PCN (Product Change Notice)

PCN Number: PCN_FrqXTAL_20250902 Affected Series: WE-XTAL Affected Part Number: see table "PART NUMBER, REVISION & DATASHEET" PCN Date: 2025-06-02 (YYYY-MM-DD) Effective Date: 2025-09-02 (YYYY-MM-DD)	Change Category: ☐ Equipment/Location ☒ General Data ☐ Material ☐ Process ☐ Product Design ☐ Shipping/Packaging ☐ Supplier ☐ Software
Contact: Product Management Phone: +49 (0) 7942 - 945 5001 Fax: +49 (0) 7942 - 945 5179 E-Mail: pcn.eisos@we-online.com	Datasheet Change: ☒ Yes ☐ No Attachment: ☐ Yes ☒ No

DESCRIPTION OF CHANGE:

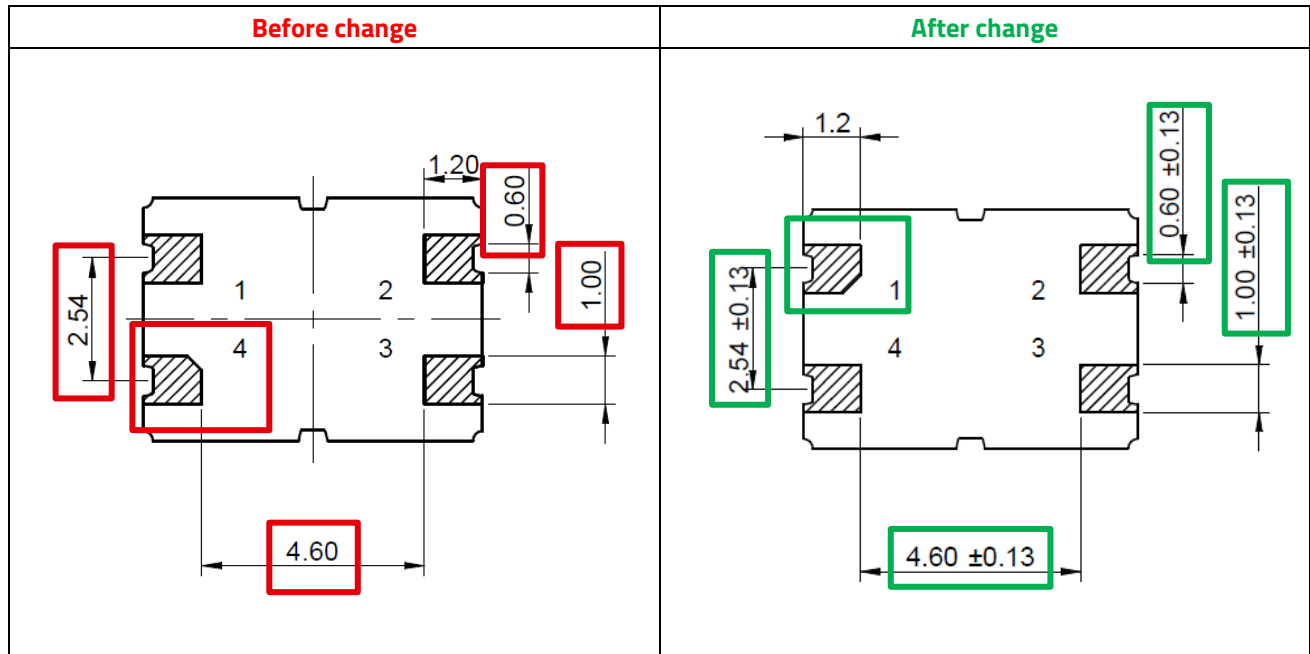
As a datasheet information amendment, Würth Elektronik eiSos will correct the location of the chamfer in the product drawing, add the tolerances of the dimensions and correct the solder pad layout.
 This is a datasheet correction only. There will be no change in form, fit, function, quality or reliability of the product.
 The preliminary datasheets of the affected part numbers which are available in the online catalogue will be available on the website after the PCN date.
 Link to the website: [WE-XTAL](#)

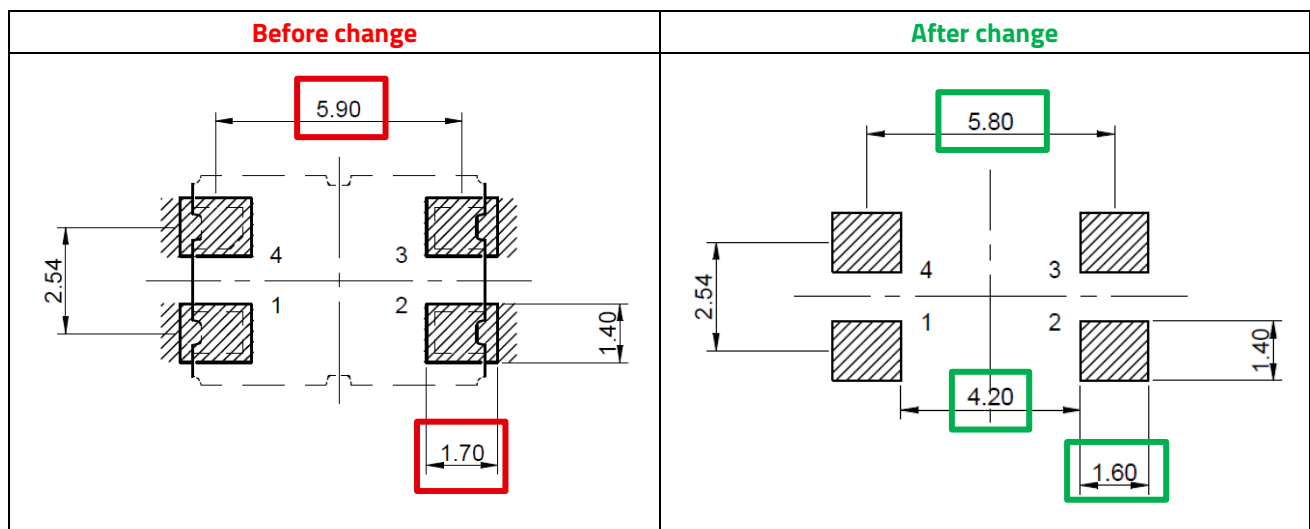
- (1) The location of the chamfer will be corrected in the product drawing from Pad 4 to Pad 1. At the same time the tolerances for the dimensions are added.
